Tierra Del Este Unit 81 B

City of El Paso — City Plan Commission — 12/6/2018

SUSU18-00098 — Major Combination

ATTACHMENT 3

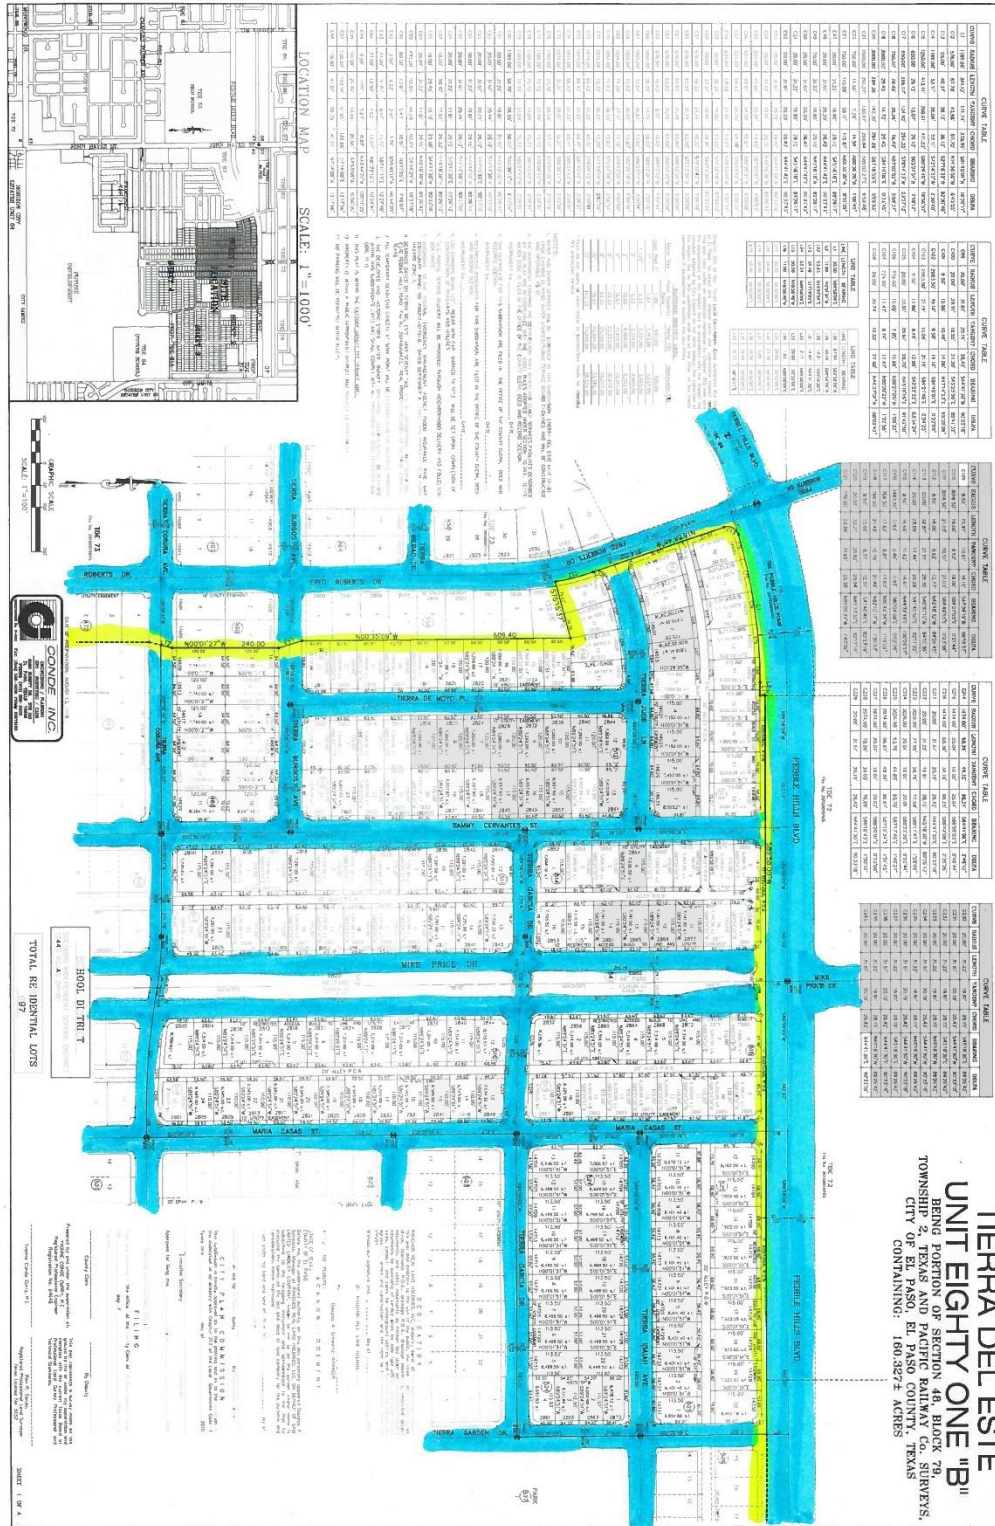
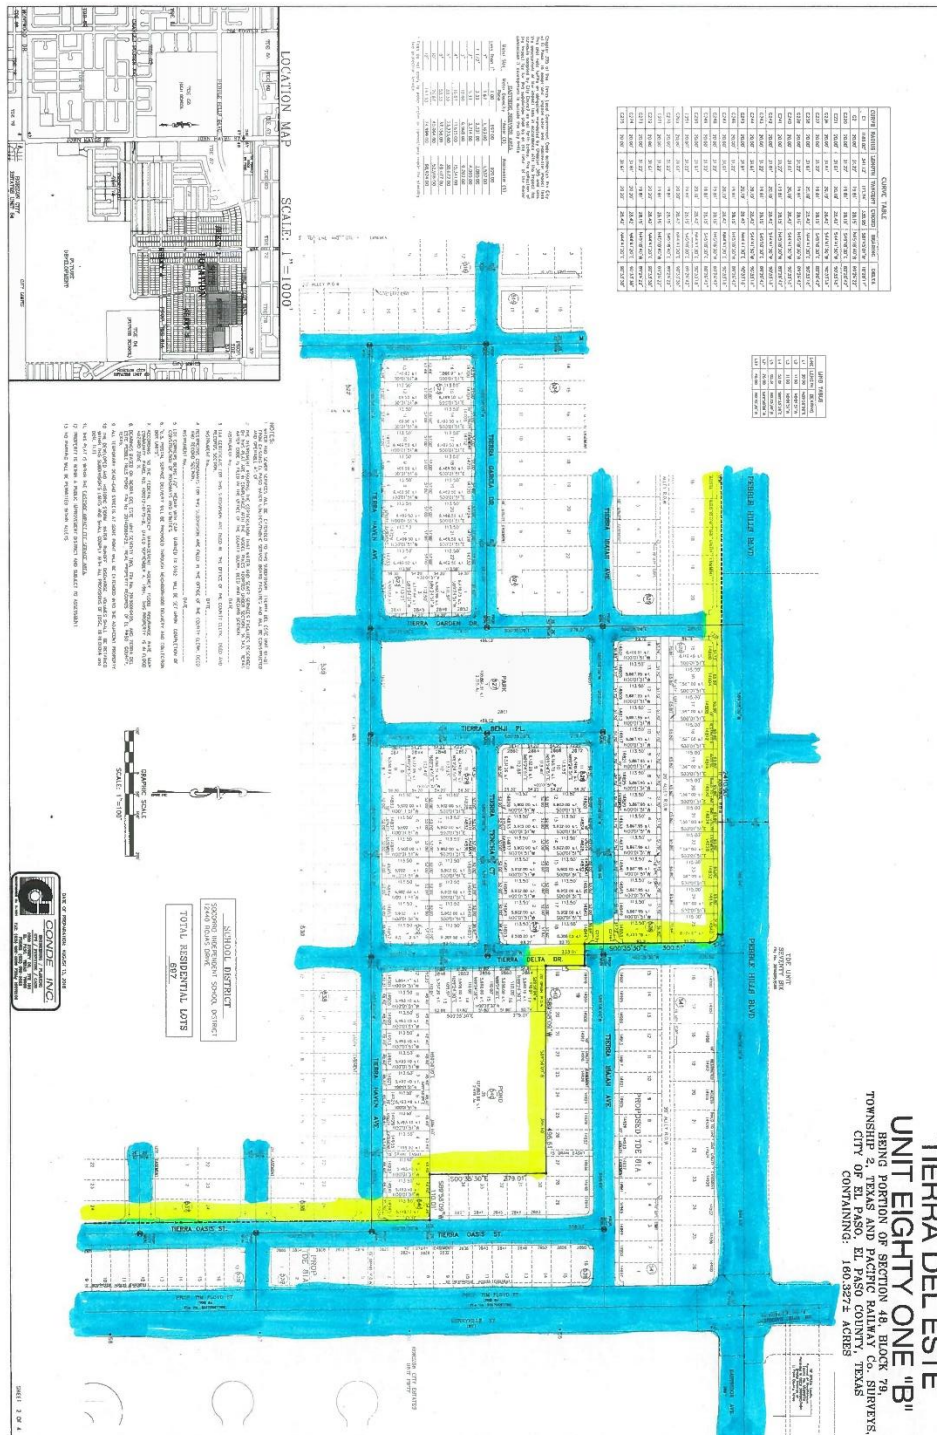
3: Add a line to the notes of the final plat for the Park Deeds.

4: Note number 1 states that water and sewer service "will be constructed and operable as of." The sentence ends without a date. Please add the date.

5: Add the name or number of the public improvement district.

6: On the Mike Price cross-section, show the build to line.

7: Add a line for the release of access document. Submit the release of access document.

8: The location map is required to be 1" = 600'. Please change the location map from 1" = 1,000' to 1" = 600'.
